TECHNICAL BULLETIN  
J034NAS1  
13 AUG 2013

**SECTION: 303-12F**

Safety Recall: Engine Charge Air Cooler Hose Detachment

**XF (X250)**

E159753

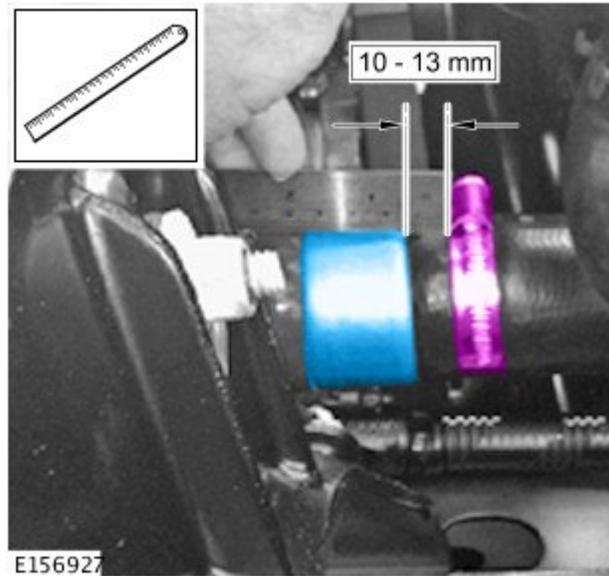
3. Check position of the charge air cooler hose clip.

- If: the clip is less than 10mm from the resonator; a gap exists between the resonator and the end of the hose; or the clip is not positioned squarely on the hose, carry on from step 4.
- If: the clip is between 10mm and 13mm from the edge of the resonator; and the hose is butted against the resonator, carry on from step 5.

4. Reposition hose correctly on the resonator and position the clip 13mm from the edge of the resonator.
5. Tighten the clip to 6Nm, ensuring the clip remains in position and square to the edge of the resonator.
6. Close hood.
